ADDENDUM #1

Date:	02.25.2014	Addendum No:	1
Project:	York General Health Care Services Hospital Addition And Remodel	Project No:	24902
To:	Jake Kulhanek	Firm:	Sampson

FLOOR PATTERN LEGEND

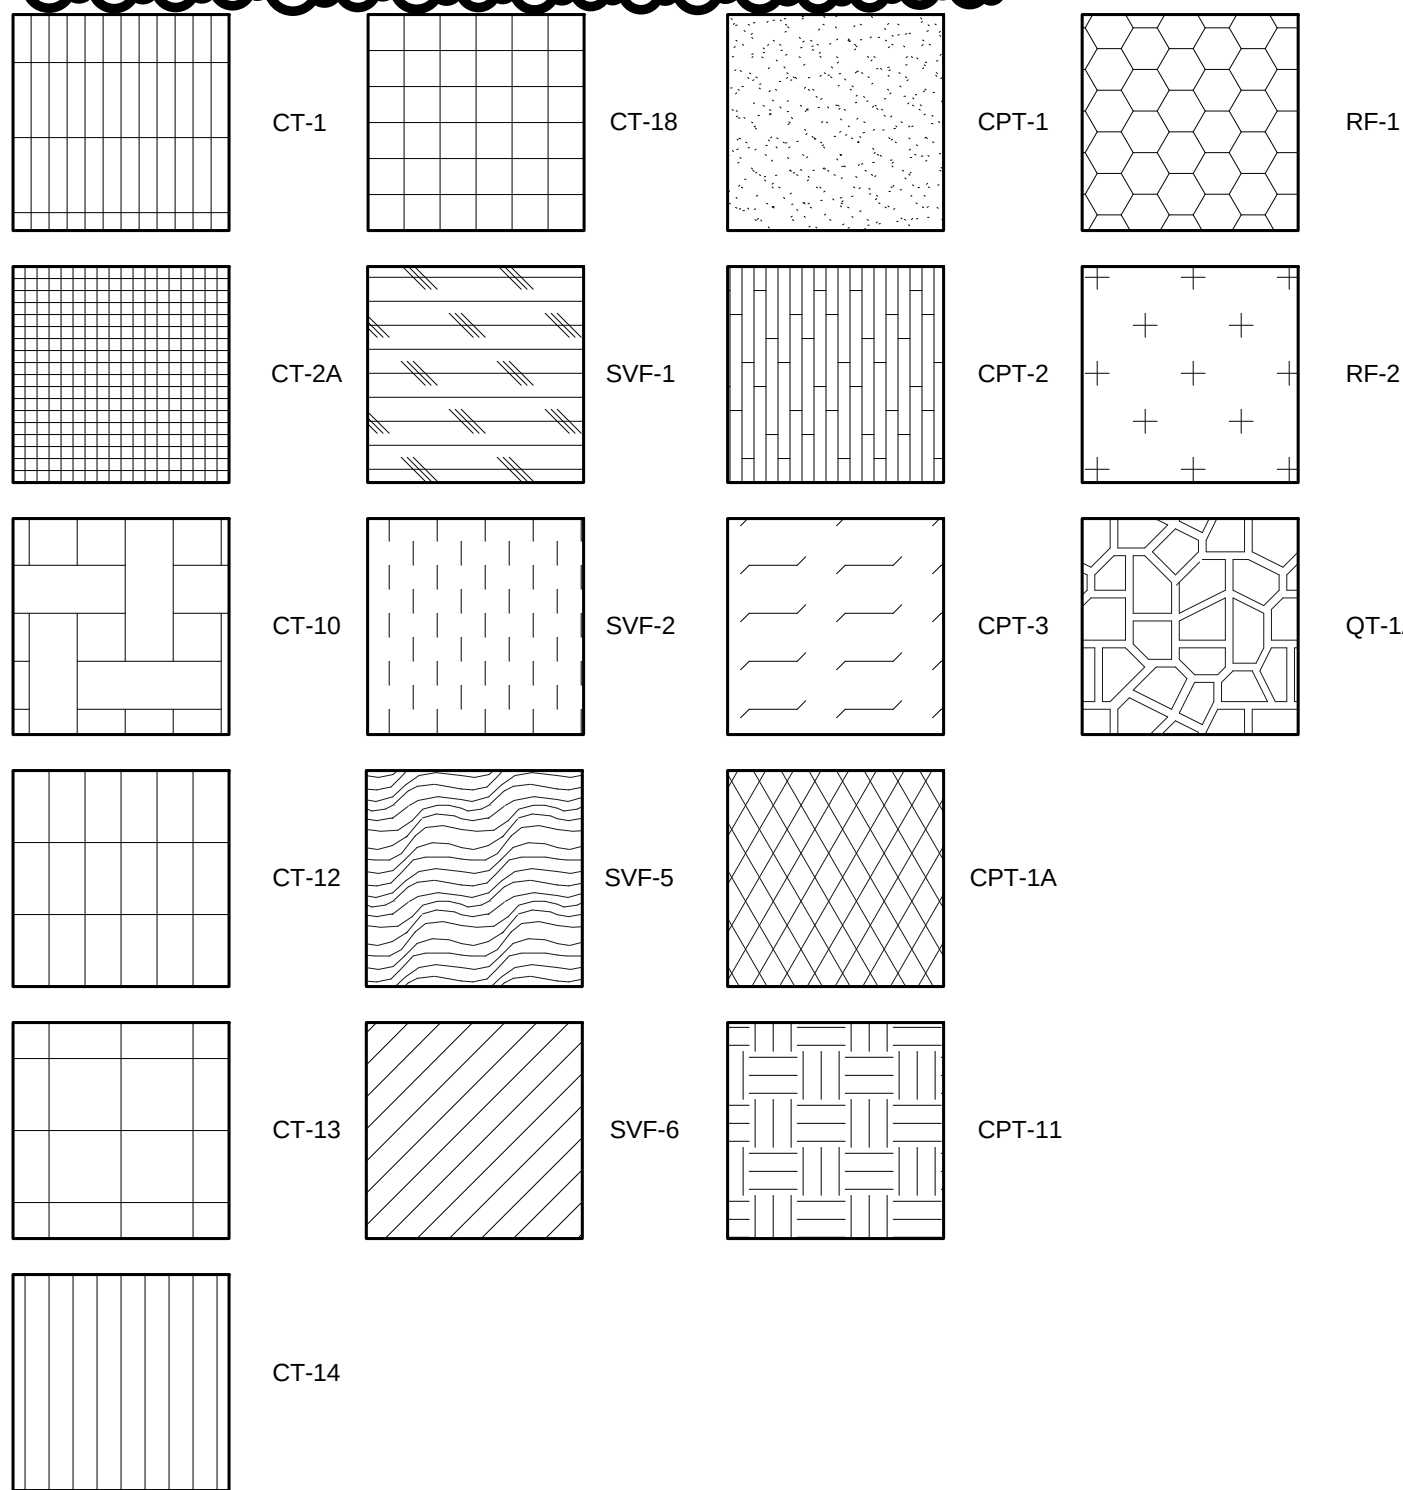
- Floor Pattern Legend, add "NOTE: SEE SHEET A3-6, COLOR AND MATERIAL SCHEDULE, FOR CODE OF ABBREVIATIONS".
